# **Staff Report Z-19-16-4** April 21, 2016

Request To: WU (Walkable Urban Code) T6:7 MT

Proposed Use: Multifamily Residential

**Location:** Northeast corner of Central Avenue

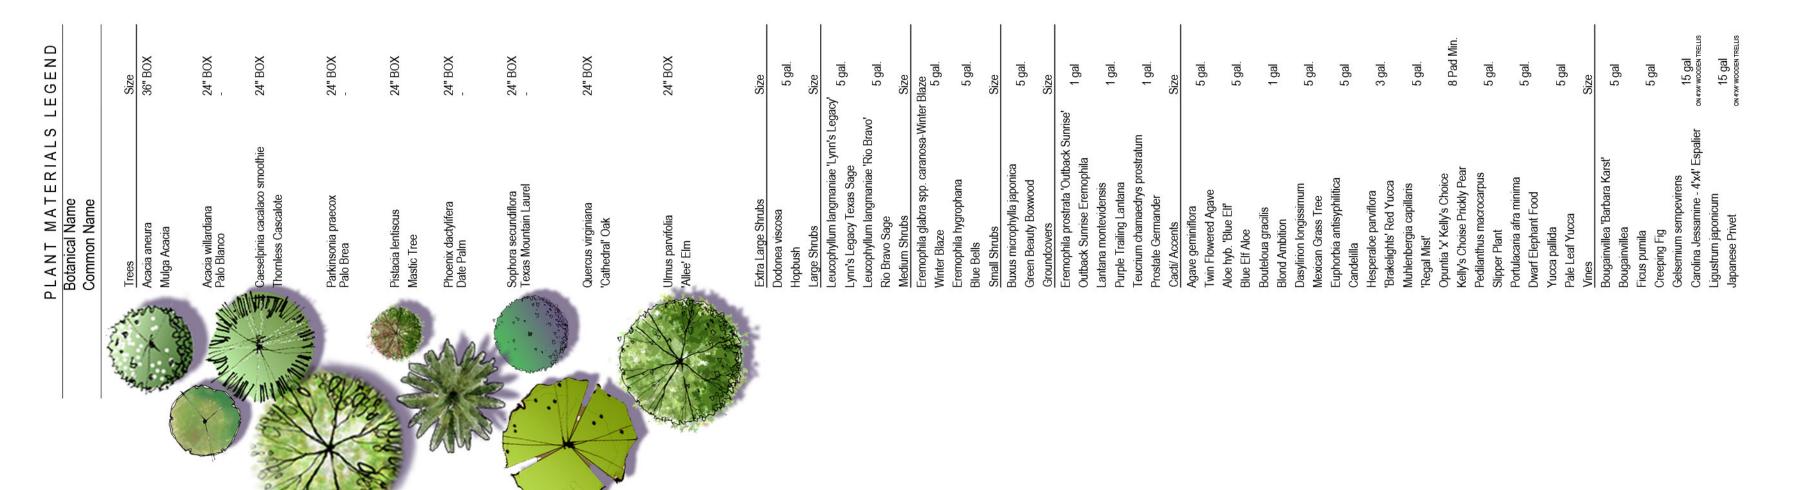
6. The conceptual proposal shows units with ground floor entrances facing both Central Avenue and Indianola Avenue. A vehicular entrance is shown on Indianola Avenue. Sidewalks should be detached from the curb, allowing trees to be planted between the curb and the sidewalk and providing a more comfortable environment for pedestrians. This design is consistent with the Council adopted Guiding Principles for Complete Streets, one tenet of which is to make Phoenix more walkable. The detached sidewalks are addressed in Stipulation #2.

<a href="https://www.phoenix.gov/pddsite/Documents/pdd\_pz\_pdf\_00408.pdf">https://www.phoenix.gov/pddsite/Documents/pdd\_pz\_pdf\_00408.pdf</a> This is addressed in Stipulation #3.
- 9. The submitted conceptual site plan reflects a suburban model for its parking standard calculation. Although its proximity to light rail provides an allowance for a 25% reduction in the amount of required spaces, the proposal does not include a reduced parking

10. The conceptual site plan proposes to adjust Indianola Avenue to provide nine on-street parallel parking spaces to serve as "teaser" parking for prospective tenants to the site. Providing on-street parking at this location appears to be at the expense of providing a good walking and bicycling environment on Indianola Avenue and is not recommended. At present, Indianola Avenue is developed as

11. Bicycle parking is a requirement of the Walkable Urban Code. The conceptual plan does not show bicycle parking however it is anticipated to be located in the garage structure. It is recommended that two types of parking be provided on the property: secured parking for residents, and rack parking for guests located near entrances to the property. The property is near a light rail transit station and several major bus routes. Providing secure bicycle parking for residents and parking for guests of the development is supportive of multimodal travel options.

- 1. The development shall detach the sidewalk and plant trees between the sidewalk and the curb on Indianola Avenue.
- 2. The development shall comply with the Central Avenue Development Standards as approved by the Planning and Development Department.
- The property owner shall record a Notice to Prospective Purchasers of Proximity to Airport in order to disclose the existence, and operational characteristics of Phoenix Sky Harbor International Airport to future owners or tenants of the property.
- 4. The applicant shall dedicate a 15 foot by 15 foot right-of-way triangle at the northeast corner of Central Avenue and Indianola Avenue.
- 5. The development shall comply with all ADA accessibility standards, as per plans approved by the Planning and Development Department.

6. The applicant shall submit a Traffic Impact Study to the City for this development. No preliminary approval of plans shall be granted until the study is reviewed and approved by the City. Contact Mr. Mani Kumar (602) 495-7129, to set up a meeting to discuss the requirements of the study. Additional improvements may be required as a result of the Traffic Impact Study.
